**May 4, 2011 TIR Addendum WEBINAR II
 FREQUENTLY ASKED QUESTIONS AND ANSWERS
 Technical Interconnection Requirements – Protection Requirements**

Technical Interconnection Requirements – Protection Requirements

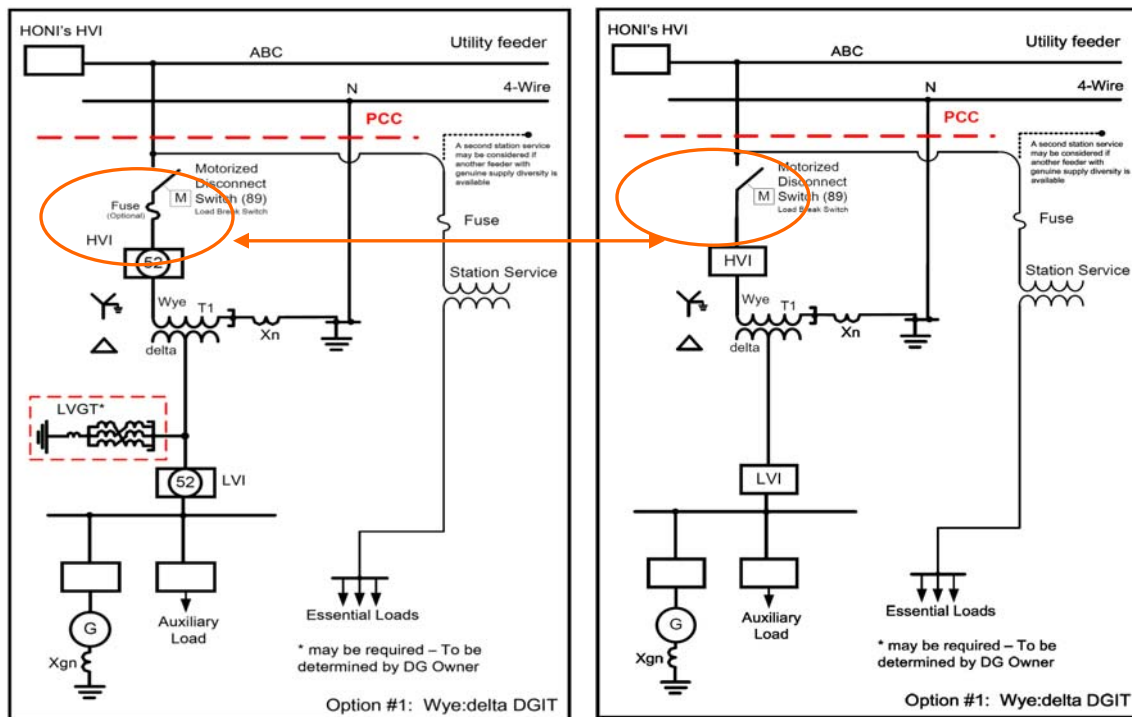
1.0 Why does Hydro One prefer a dedicated inter-connection protection?

The inter-connection protection at a DG facility refers to the tele-protection, phase and ground fault protection for faults on distribution feeders, unbalance protection and anti-islanding protection. A typical 1-line schematic is shown below and there are numerous elements that are required to be included in this protection as per the TIR. Implementing all these protections in various equipment is not an easy task. Therefore, the provision of a dedicated protective device for this purpose would make the design simpler and more reliable. Also, this would make the review of the proponent’s design and settings (required per section 2.3.1 of the TIR) easier and independent from other protections that would not impact the Hydro One system. Another benefit of this independent protection is the capability of recording events and disturbances when faults occur on the system, which may impact the Hydro One system.
